SD9000

model SD9000

Stereo Cassette Deck

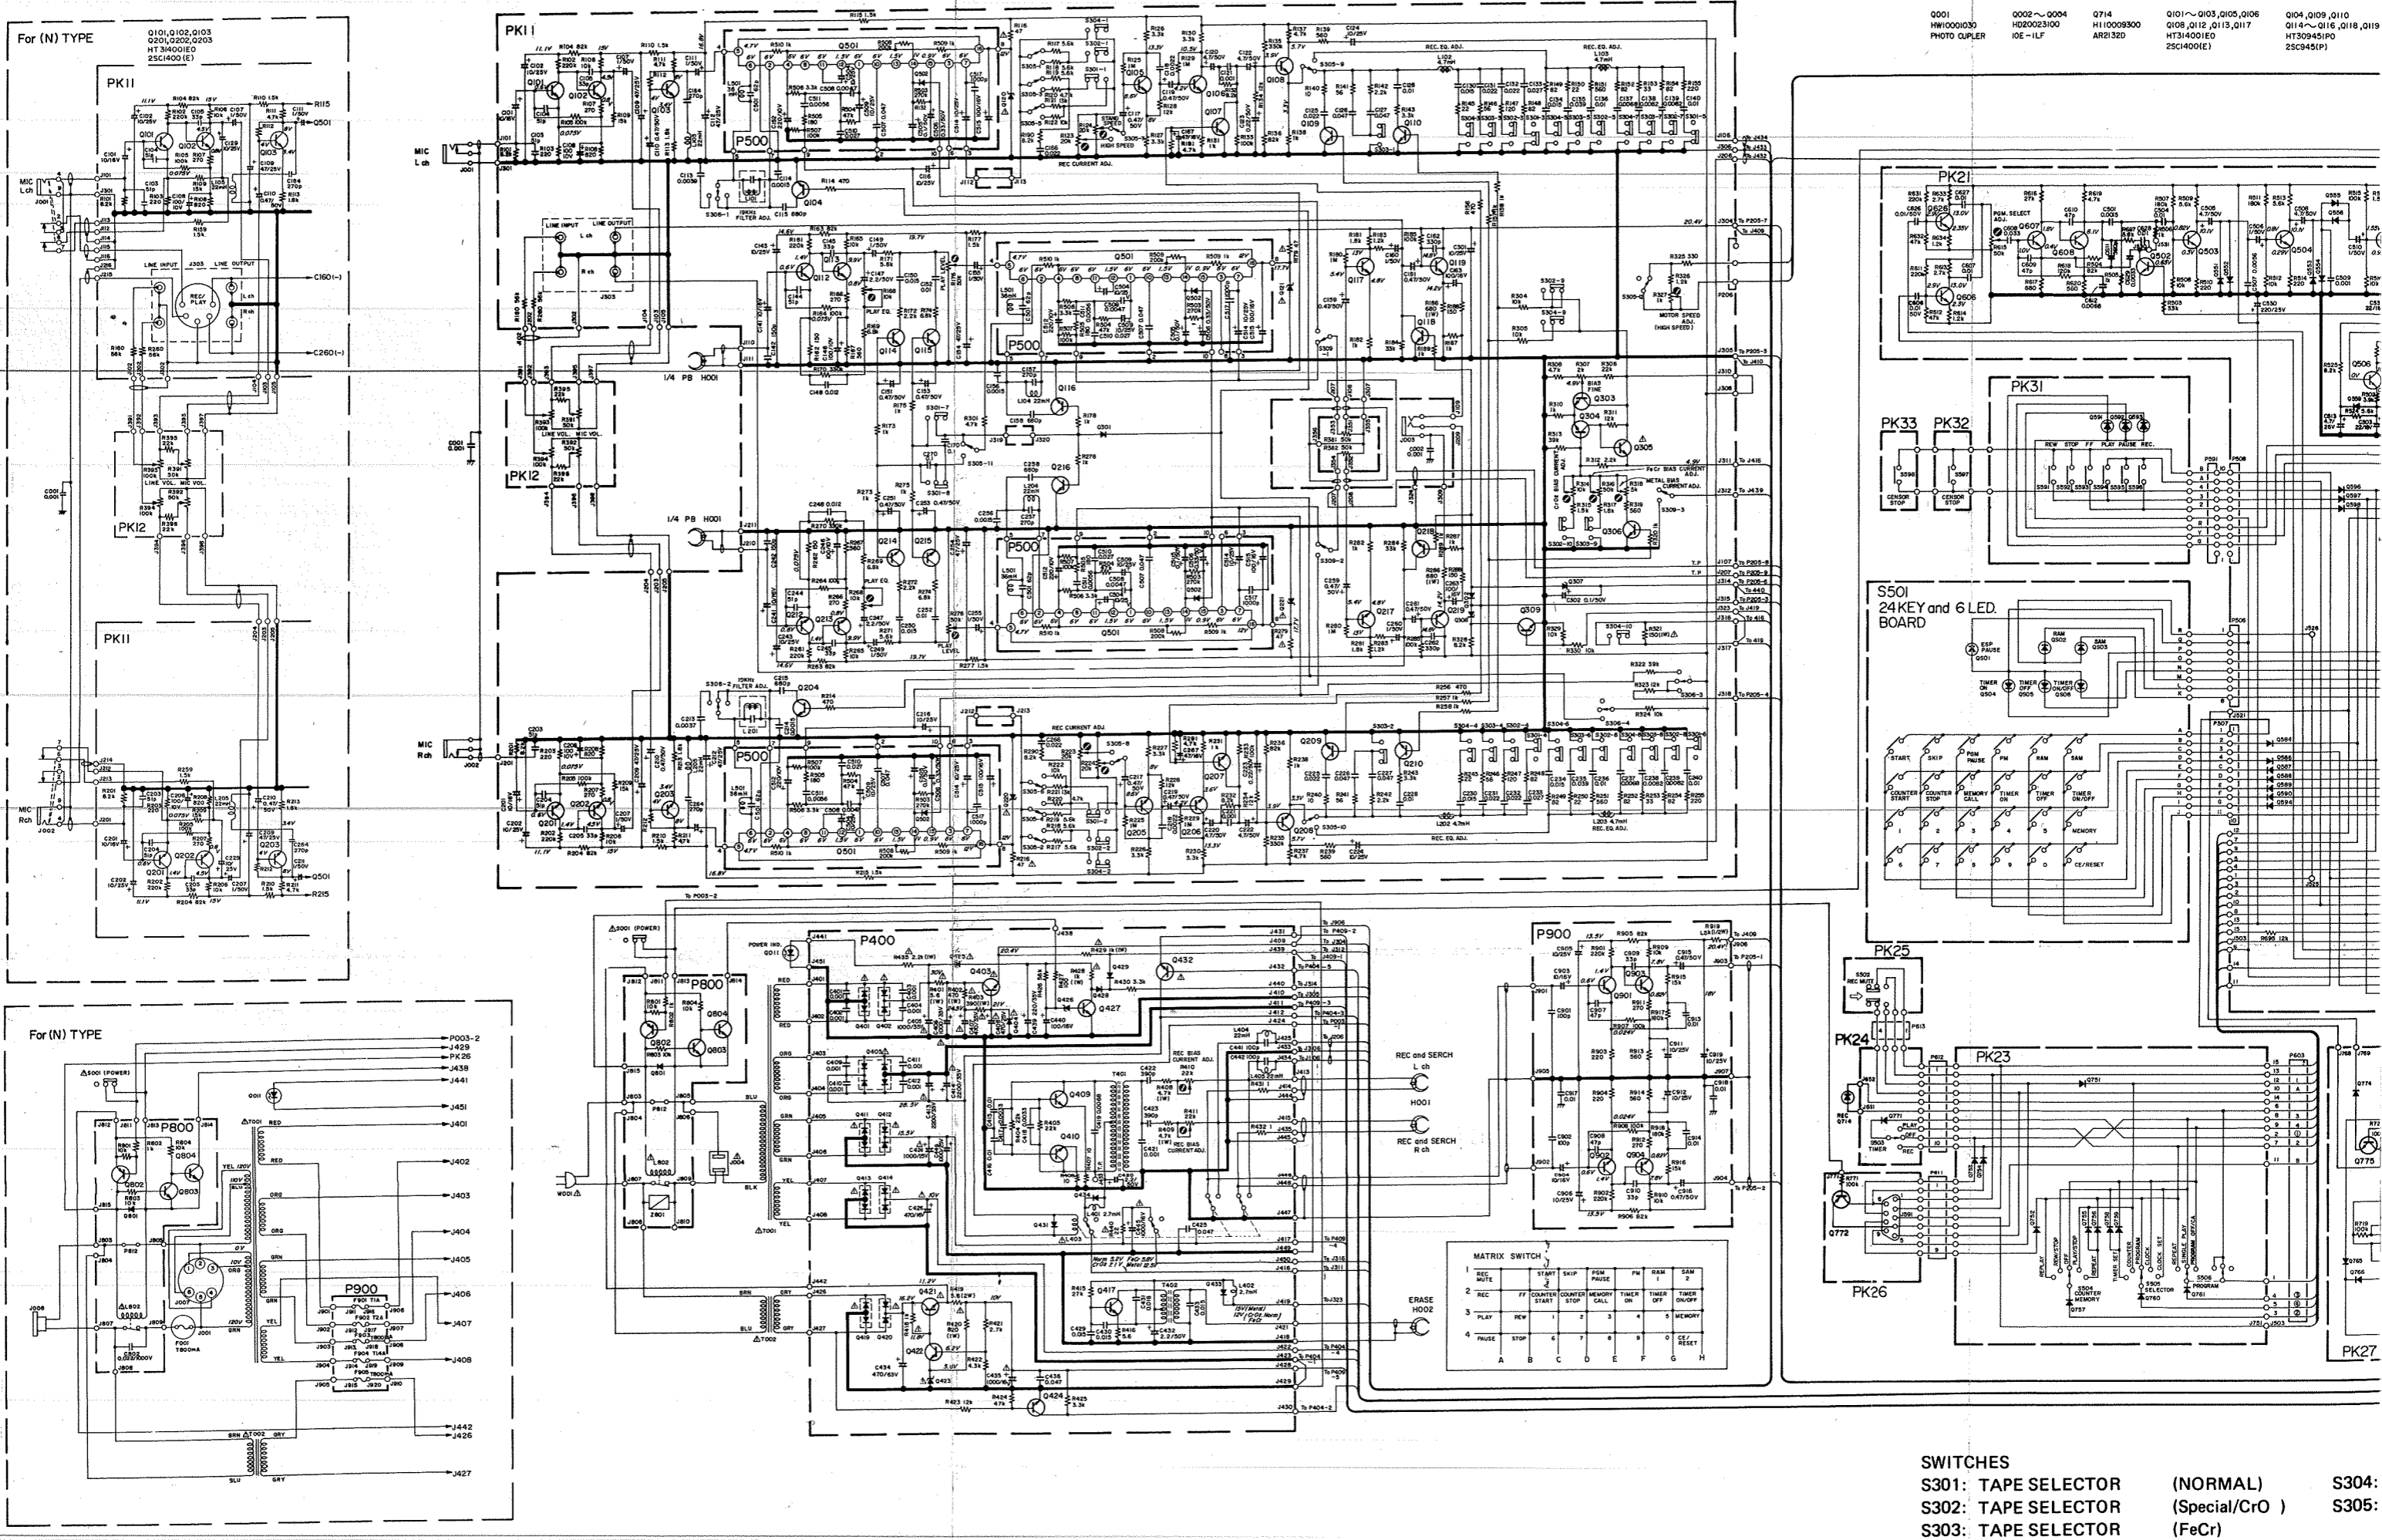
(N)TYPE ONLY		(U,C)TYPE ONLY	
Q107, Q207 HT402272A0 25D227(10xV)	Q111, Q211 HT309451P0 25C945(P)	Q107, Q207 HT320011K0 25C200(K)	
Q421 HT407181B0 25D718(B)	Q421 HT403131F 25D313(F)
